Planning and Assessment

Gateway determination report

LGA	Canterbury-Bankstown
PPA	City of Canterbury Bankstown
NAME	Western Sydney University Campus
NUMBER	PP_2019_CBANK_004_00
LEP TO BE AMENDED	Bankstown Local Environmental Plan 2015
ADDRESS	74 Rickard Road and Part 375 Chapel Road Bankstown
DESCRIPTION	Lot 5 DP 777510 and Lot 6 DP 777510
RECEIVED	31 October 2019
FILE NO.	IRF19/7739
POLITICAL DONATIONS	There are no donations or gifts to disclose and a political donation disclosure is not required
LOBBYIST CODE OF CONDUCT	There have been no meetings or communications with registered lobbyists with respect to this proposal

Figure 7: Bankstown LEP 2015 Heritage Map (HER_005)

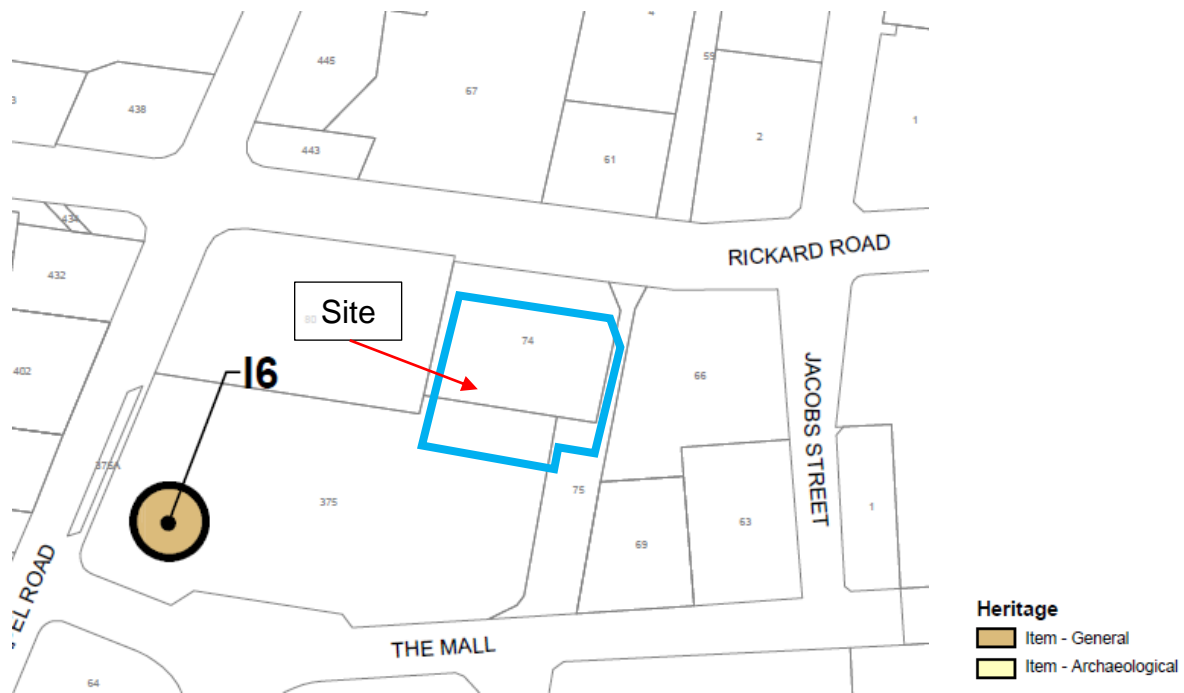
The heritage and special provisions maps have not been included in the planning proposal. The inclusion of the maps in the planning proposal for information purposes is recommended prior to public exhibition and is to be a condition of the Gateway determination.

- (c) include the existing LEP maps:
 - i. Heritage Map; and
 - ii. Special Provisions Map.
 - (d) update proposed LEP maps to the Department's standards and provide a map of the exact extent of Paul Keating Park the solar access control will apply to;

Figure 20: Proposed Bankstown LEP 2015 FSR Map (Source: Council)

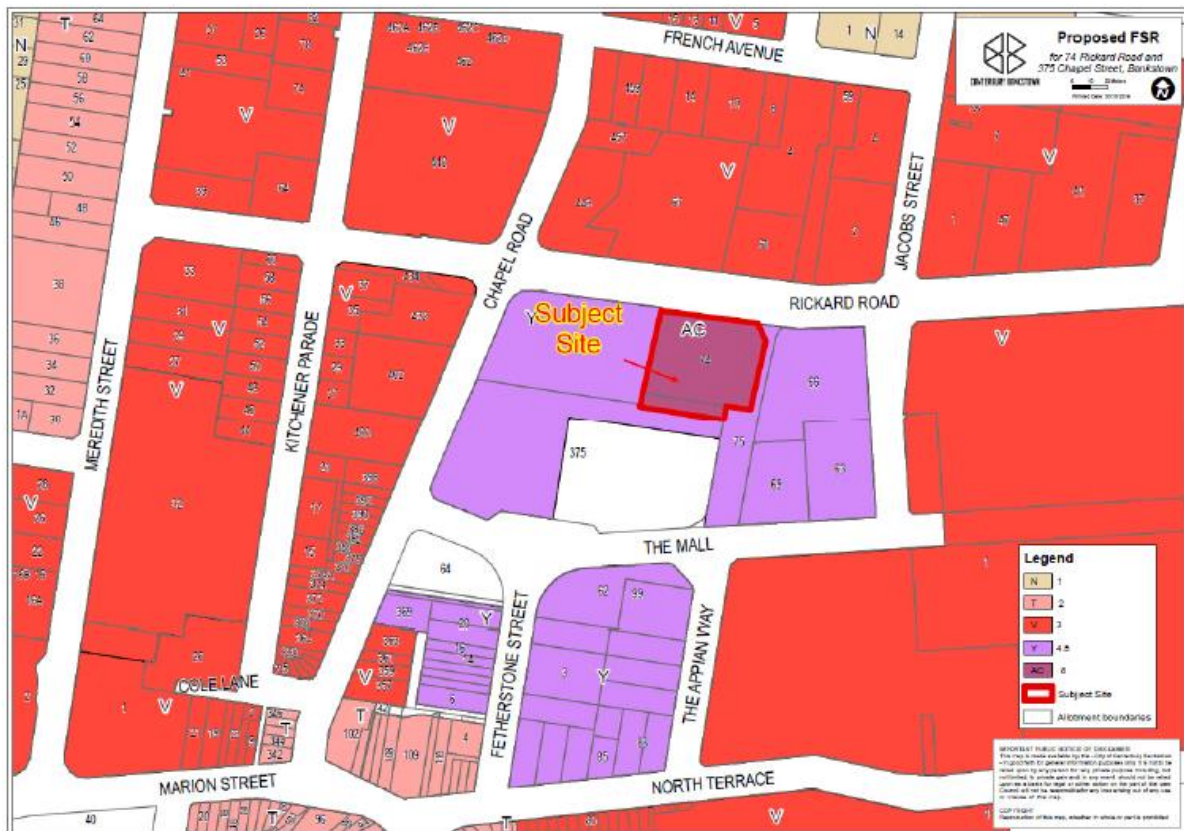
Draft LEP Maps have been provided as part of the proposal (**Attachment V and Figures 20 and 21**). However, the maps will be required to be updated to Department standard prior to public exhibition and the exact extent of Paul Keating Park should be included in the planning proposal.

Figure 22: Existing built form. Cumulative overshadowing impact 11am to 3pm, June 21 (overlay by DPIE)

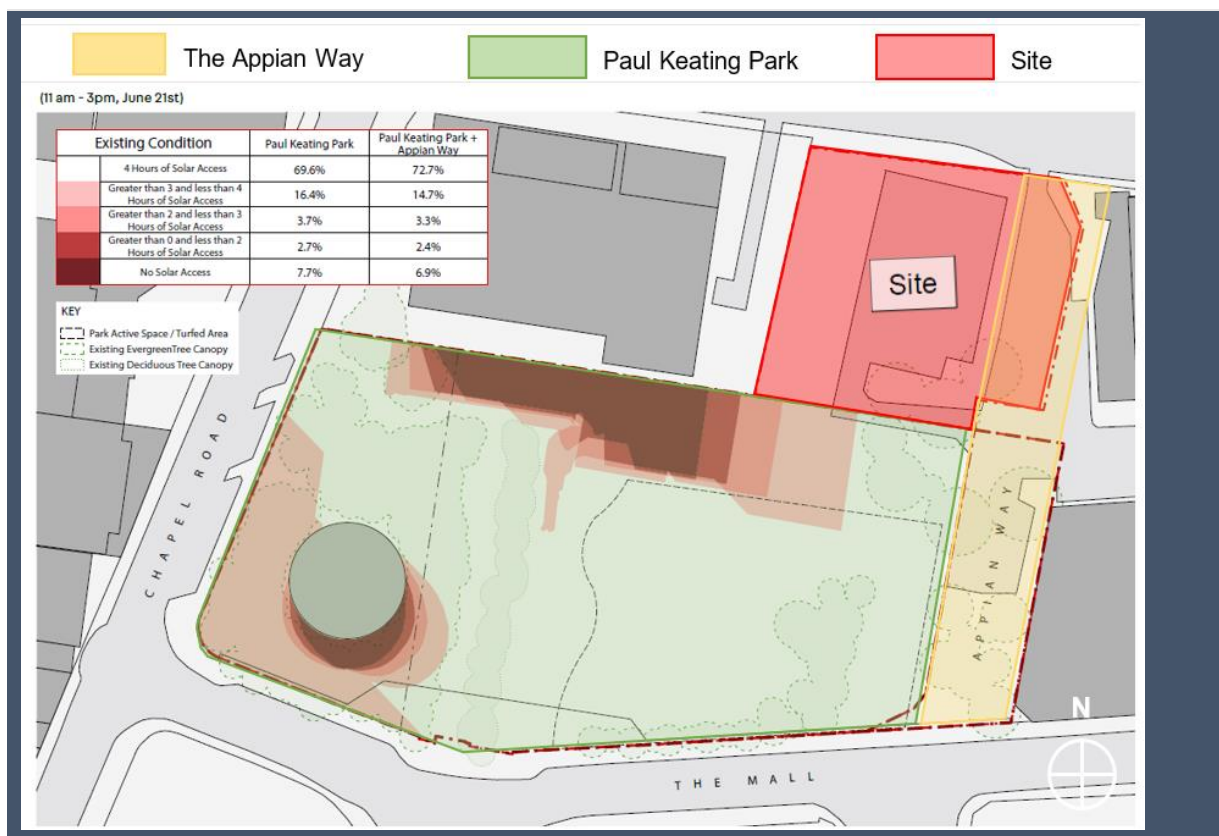
The Department is supportive of a control which would maintain solar access to Paul Keating Park which is identified as key open space in Council's LSPS. However, Council has not provided enough evidence to demonstrate that compliance with the solar access control can be achieved if the site is developed to the proposed height and FSR.

Council's Solar Amenity Study indicates that currently 81.6% of Paul Keating Park receives at least four hours of solar access in mid-winter (**Figure 22**). The same study found that if the site was developed to its current maximum potential, 57.3% of the park would receive four hours of sunlight achieving compliance with the control (**Figure 23**). However, if the site was developed to the proposed maximum development standards adopting the built form preferred by WSU, only 41.2% of the park would achieve four hours of solar access (**Figure 24**). It is also noted that the Solar Amenity Study indicates that if all lots adjoining Paul Keating Park were developed to their current maximum potential, solar access would decrease drastically.
